December 18, 2003
9704-MSS-058

DOCUMENT CONTROL DESK
UNITED STATES NUCLEAR REGULATORY COMMISSION
WASHINGTON, D.C. 20555

Enclosures: GT STRUDL Program Report Forms 2003.3 through 2003..8 and 2003.11

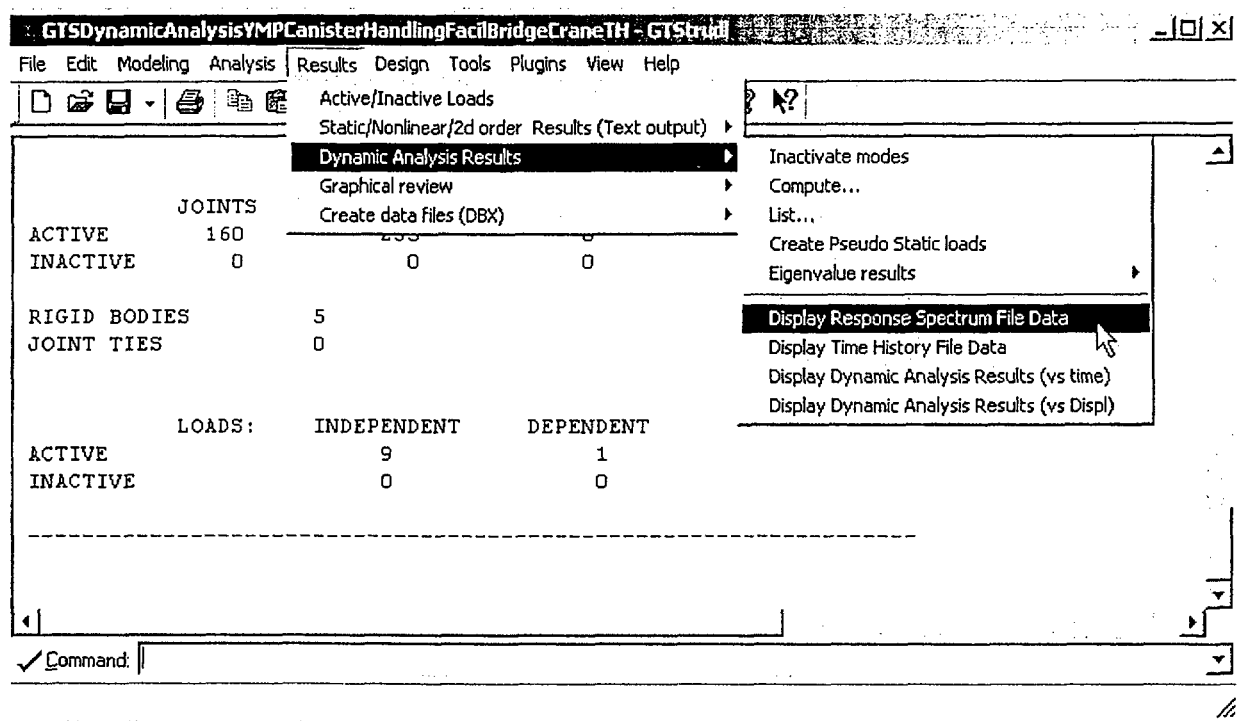
The horizontal frequency/period axis of response spectrum x-y plots created from the graphical user interface is incorrect when the active angular unit is CYCLES. The menu selection to create these plots is illustrated below:

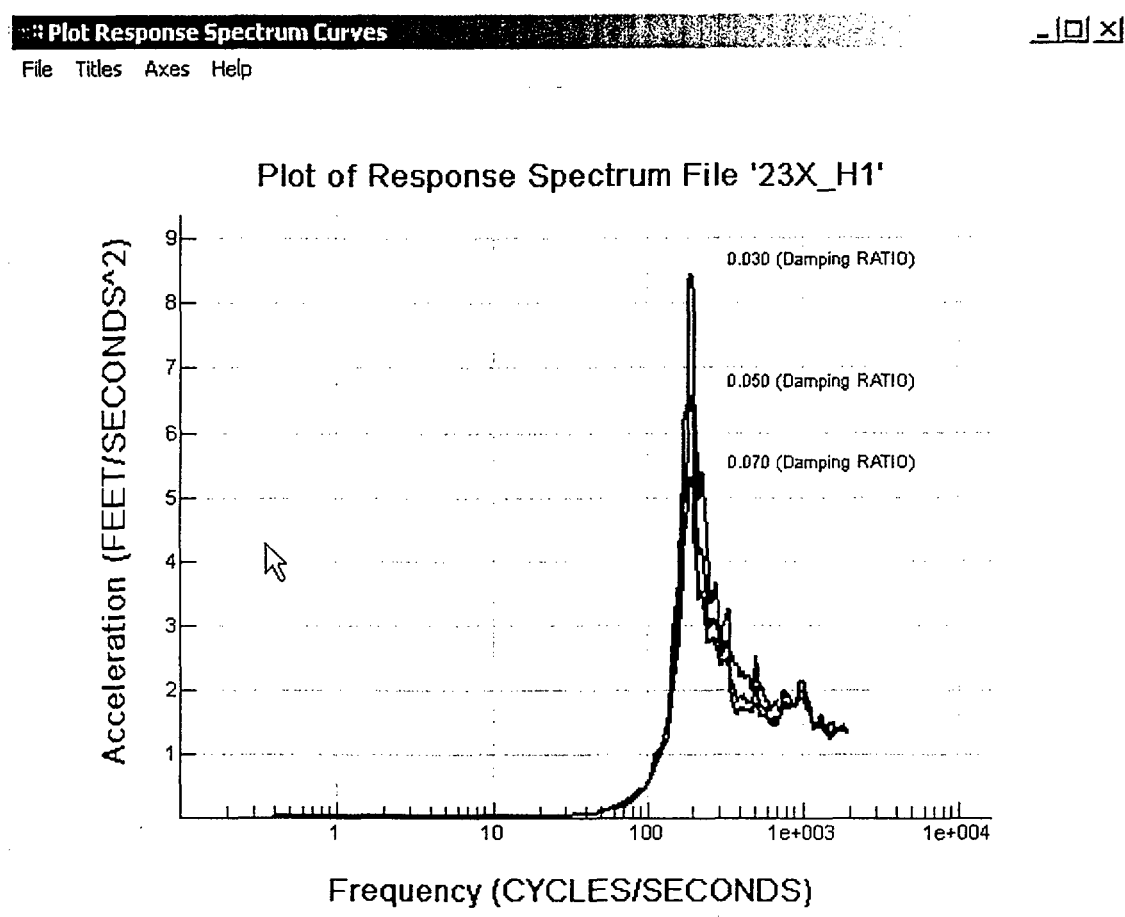
The figure below illustrates an erroneous response spectrum plot:

The largest frequency value in the data used to create this plot was 49 Hz. The frequency scale is in error by a factor of $4\pi^2$, which is very noticeable.

The work-around to produce correct plots is to set the active angular unit to RADIANS or DEGREES prior to creating the plot.
